Office Action Summary

09/838,348

OJANEN, RANDALL W.

DETAILED ACTION***Claim Rejections - 35 USC § 112***

Fig. 15

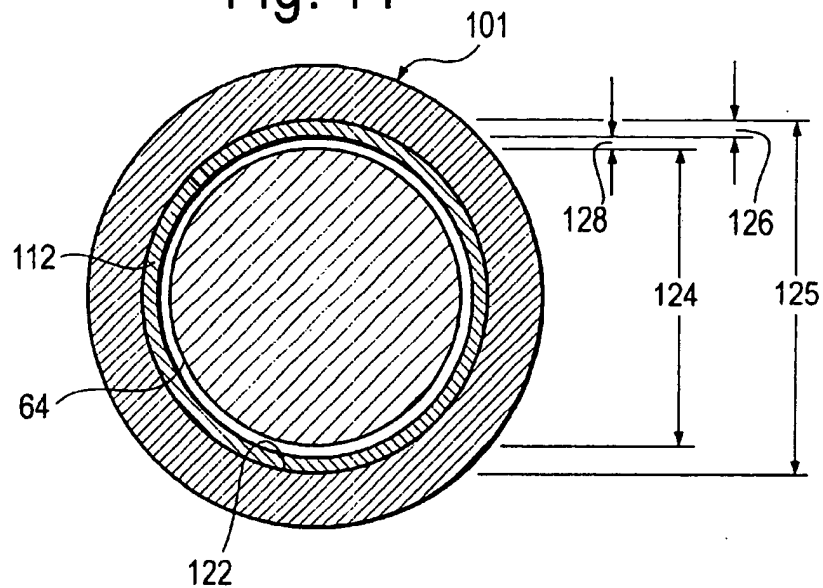
Sollami discloses a cutting tool assembly, said assembly comprising:
a cutting tool (10") a retainer sleeve (38") carried by the cutting tool, and including at least one radially outward protruding surface (31); wherein said retainer has a cylindrical circumference and a thickness dimension, the amount of radial projection of said protruding surface beyond the cylindrical surface of the retainer is between about 15 percent and about 30 percent of the thickness dimension of said retainer (see attached marked up Fig. 15).

Applicant argues that Sollami '652 does not show the dimension of the dimples as called for in the claims. The examiner disagrees and would like to direct applicant to attach marked up Figure 15, wherein the dimension of the dimples being about 15 to 30 percent the thickness of the retainer is clearly met.
